DOCKETED	
Docket Number:	23-AFC-02
Project Title:	Elmore North Geothermal Project (ENGP)
TN #:	254014
Document Title:	Elmore North Geothermal Project CURE Data Response Set 2 (Responses to Data Requests 97 to 247)
Description:	N/A
Filer:	Lindsey Xayachack
Organization:	Jacobs
Submitter Role:	Applicant Consultant
Submission Date:	1/19/2024 2:30:01 PM
Docketed Date:	1/19/2024

CURE Data Response Set 2 (Responses to Data Requests 97 to 247)

**Elmore North Geothermal Project
(23-AFC-02)
January 18, 2023**

Figure DR 182
Agricultural Return Flows
 Elmore North Geothermal Project
 Imperial County, California

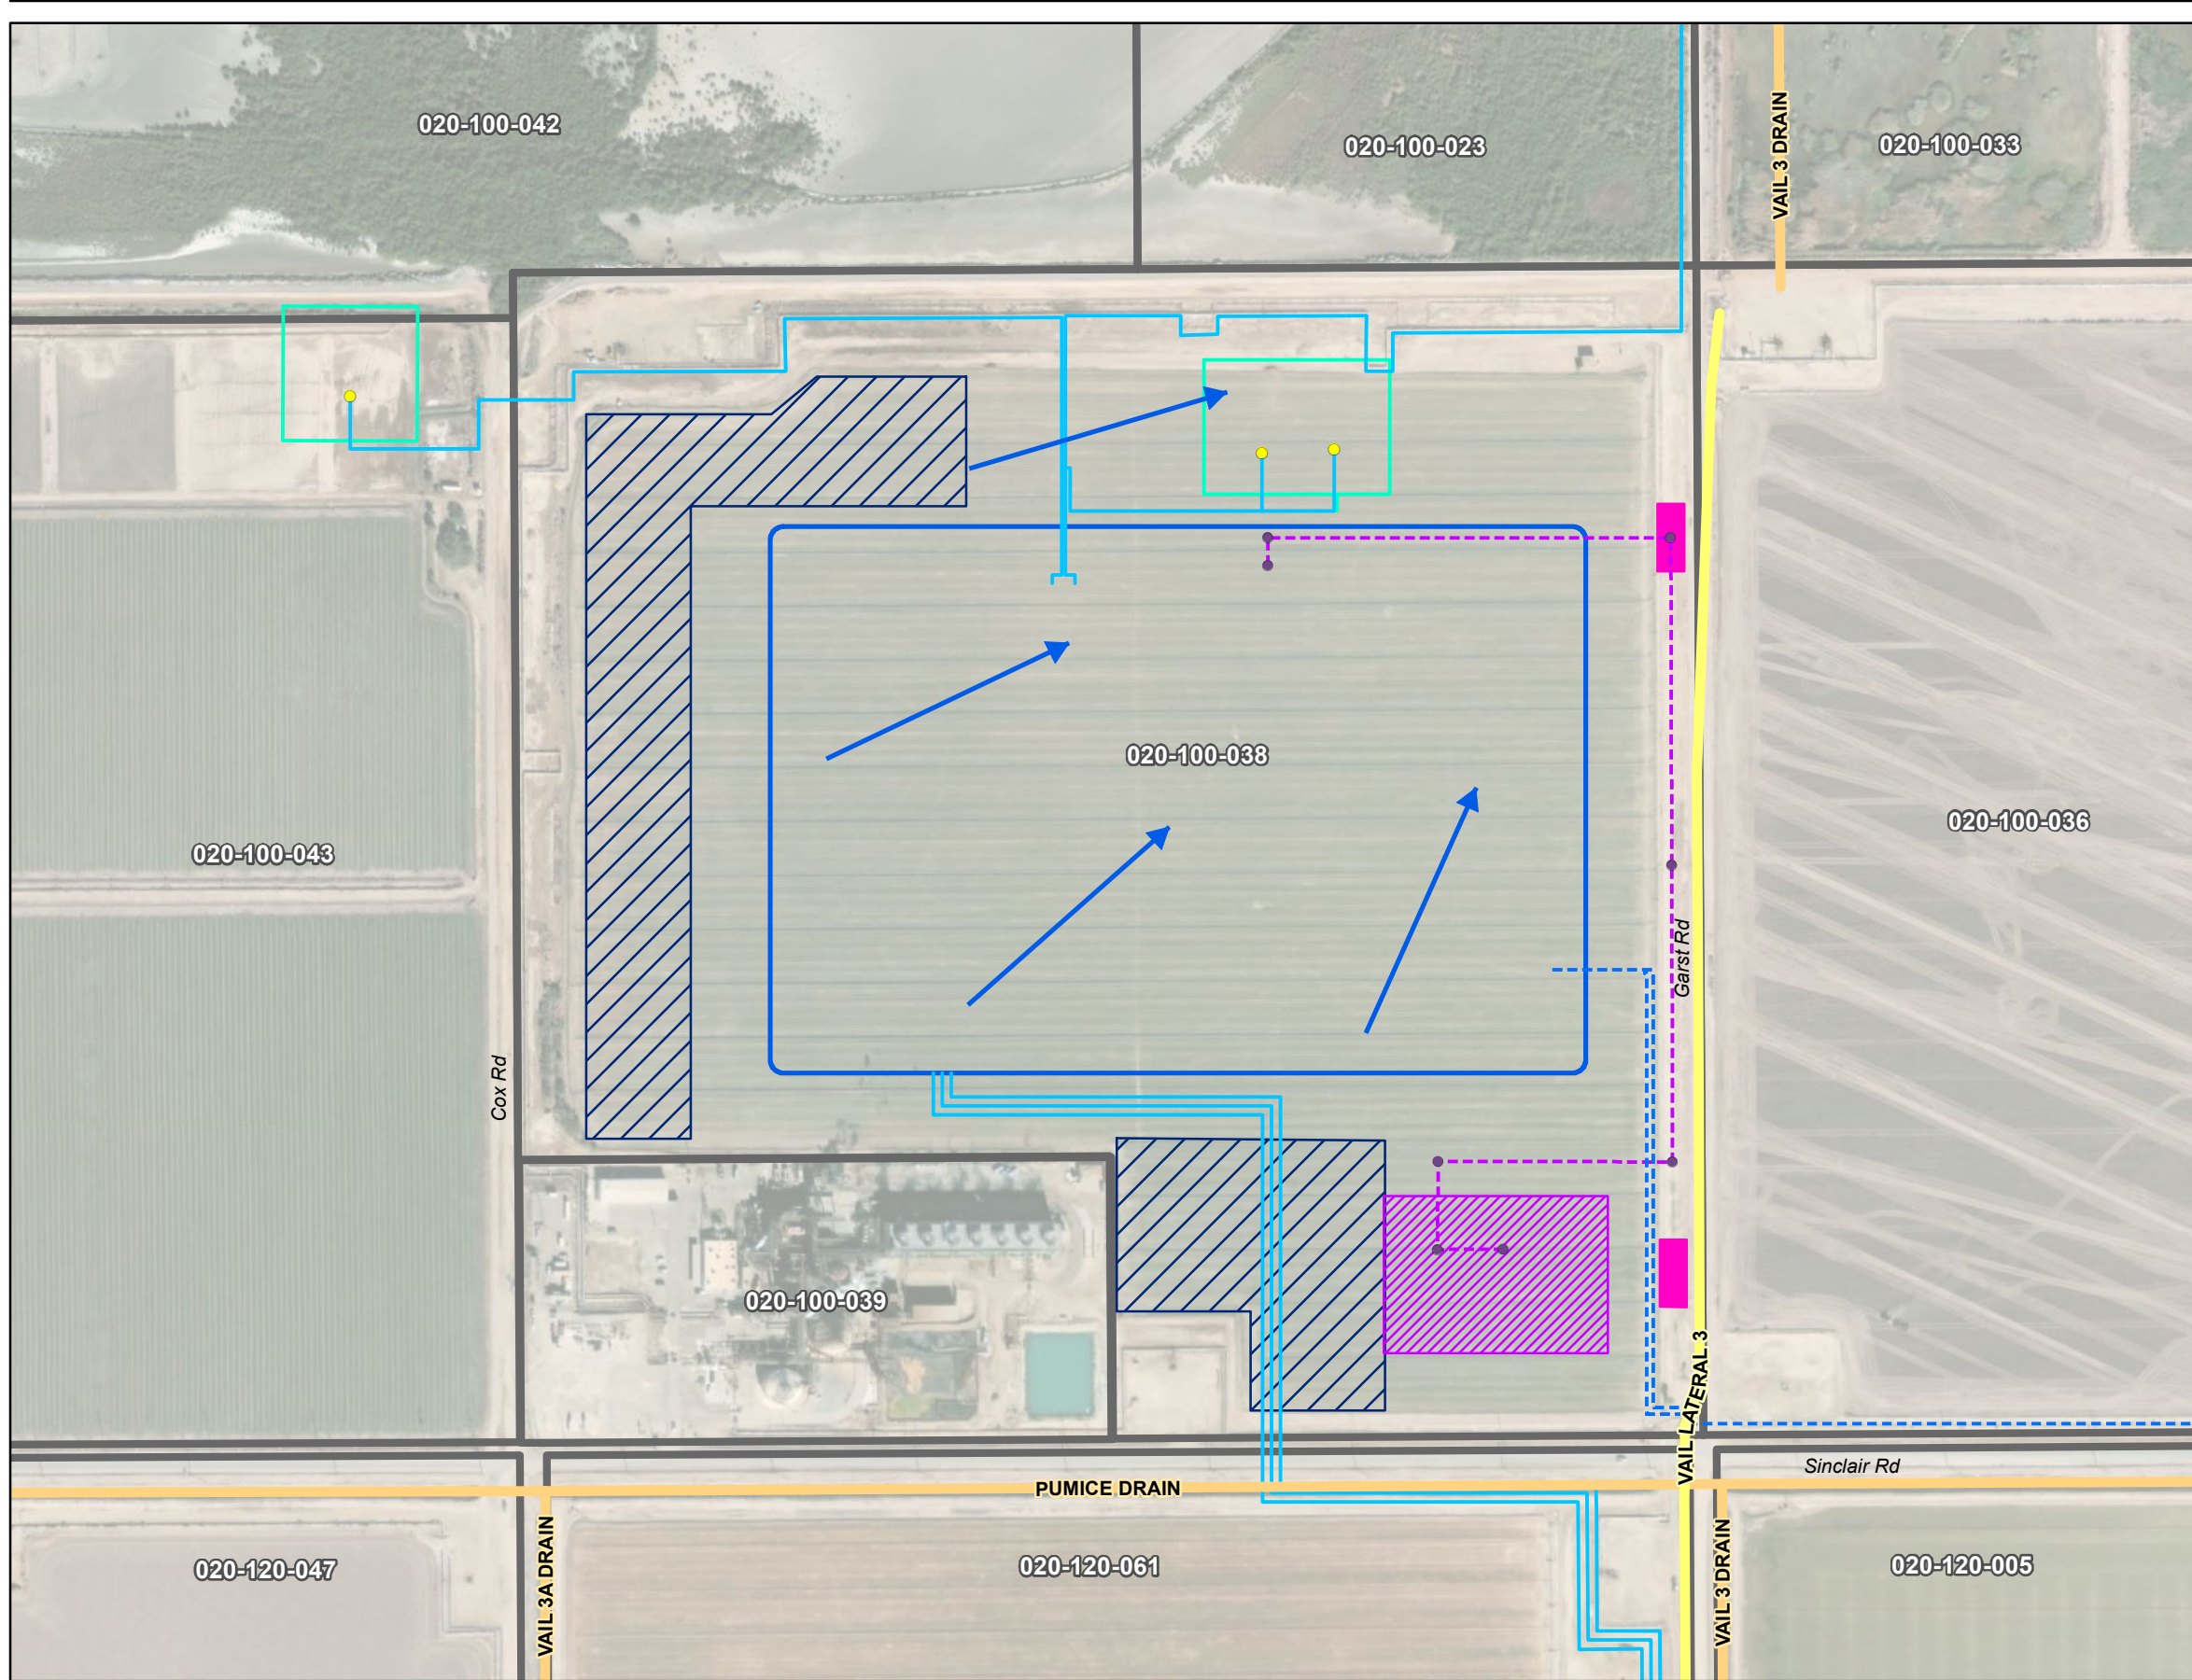
182. *Provide a map that identifies the path of agricultural return flows (irrigation runoff) from the agricultural fields that would be impacted by the Project.*

Response: Figure DR 182 identifies the Project site and the existing agricultural runoff for APN 020-100-038 are pumped to Red Hill Bay.
